First Revision No. 55-NFPA 780-2023 [Global Input]

Committee: LIG-AAA

Figure A.4.15.2.5.1 Illustration of Bonding Distance.

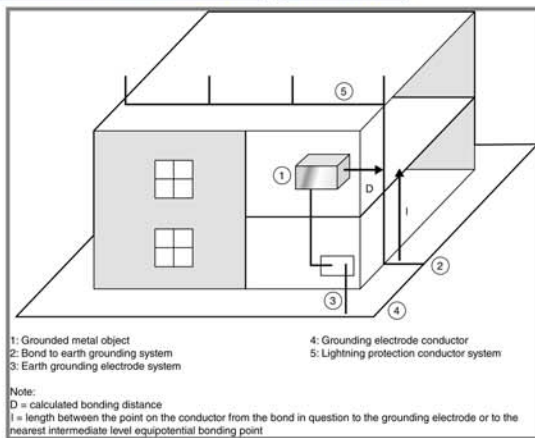
See [Figure A.4.15.2.5.1](#) for an illustration of bonding distance.

Committee Statement: Sideflash voltage is influenced by the impedance of the total distance between the point of consideration and the grounding point or the closest equipotential bonding point. Annex material has been added to point out the similarities between the standards and reasons for the differences. Existing text of 4.15.2.5.2 was moved to the proper location for “n” in equation 4.15.2.5.1.

Figure 8.3.2 Metallic (Faraday-Like) Cage.

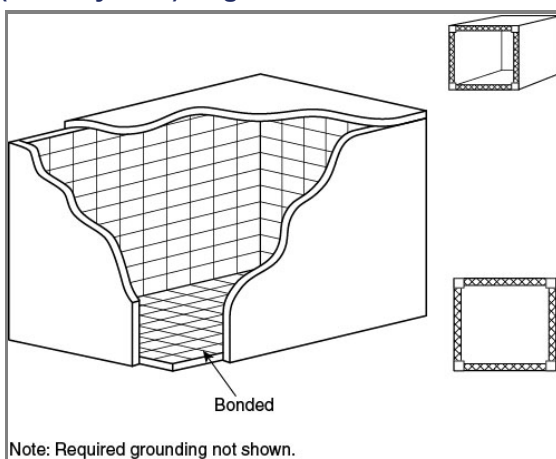
Where optimum protection for structures housing explosives is required, such as protection from electromagnetic coupling or inducing potentials such as LEMP (as determined by the AHJ), a grounded, continuously conductive enclosure, as like that shown in Figure 8.3.2, shall be used.

Response Message: FR-43-NFPA 780-2023

Figure 10.3.1.2 Diagram of Defining the Zone of Protection in a Boat with Masts in Excess of 50 ft (15 m) Above the Water. [Protection based on lightning strike distance of 100 ft (30 m).]

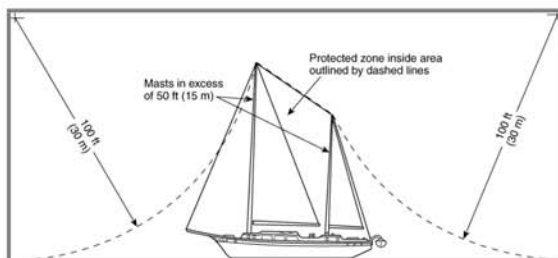
The zone of protection afforded by any configuration of masts or other elevated conductive objects shall be determined graphically or mathematically, as shown in Figure 10.3.1.2 or in accordance with 4.7.3.3. The distance can be determined analytically for a 100 ft (30 m) striking distance with the following equation (units shall be consistent, ft or m):

10.3.1.2 is revised to refer to 4.7.3.3 which contains the same equation.

Figure B.3.2.2 Lightning Protection Design Using the Rolling Sphere Method.

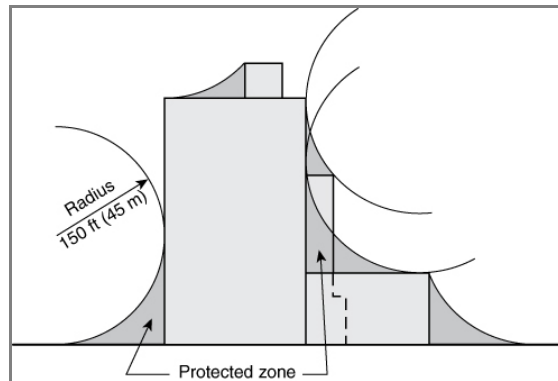
The rolling sphere method was incorporated into NFPA 780 in the 1980 edition. It originated from the electric power transmission industry (lightning strike attachment to phase and shield wires of lines) and is based on the simple electrogeometric model. To apply the method, an imaginary sphere is rolled over the structure. All surface contact points are deemed to require protection, while the unaffected surfaces and volumes are deemed to be protected, as shown in Figure B.3.2.2.

Where the RSM is applied to a building of height greater than the selected sphere radius, the sphere touches the vertical edges will touch vertical walls without protrusions on the sides of the building at all points above a height equal to the sphere radius. This indicates the possibility of strikes to the sides of the building and raises the question of the need for an air terminal network in these locations. Studies show that strikes to vertical edges on the sides of tall buildings do occur but are not very common. There are theoretical reasons for believing that only flashes with low I_p , and consequently low d_s , values are likely to be able to penetrate

Response Message: FR-61-NFPA 780-2023

Figure L.2.1 2007–2016 Average US Lightning Flash Ground-Strike Density Map (Flashes Ground Strikes per Square Kilometer per Year). (Courtesy Vaisala, Inc.)

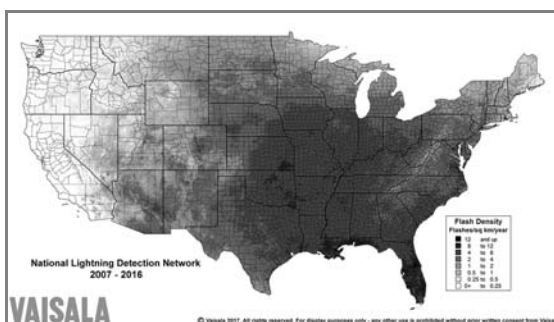
Lightning flash ground-strike density, the yearly number of flashes strike points to ground per square kilometer, can be found in Figure L.2.1 . A color version of this map with a resolution of 2 km can be found at www.vaisala.com/en/products/data/data-sets/nldn.

Response Message: FR-78-NFPA 780-2023

Figure L.6.6.1.2 Collection Areas (A_D , A_M , A_L , A_{DJ} , A_I). (Source: IEC.)

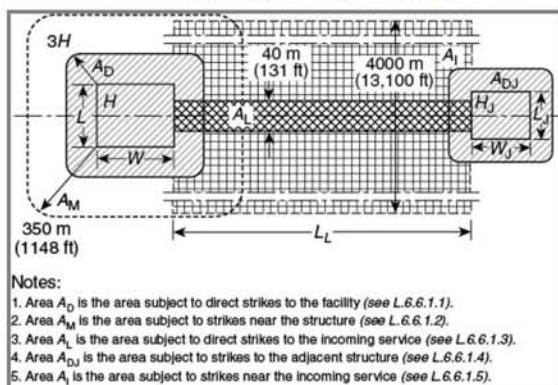
The annual threat of occurrence due to strikes near a structure (N_M) is given by the following equation (see Figure L.6.6.1.2):

A_M = collection area of flashes ground strike-points near the structure (m²) (see Figure L.6.6.1.2)

A_D = equivalent collection area of the structure (m²) (see Figure L.6.6.1.2)

The collection area for flashes near the structure (A_M) includes the area extending a distance of 350 m (1148 ft) around the perimeter of the structure. For cases where N_M is negative, a value of 0 is assigned to N_M used instead.
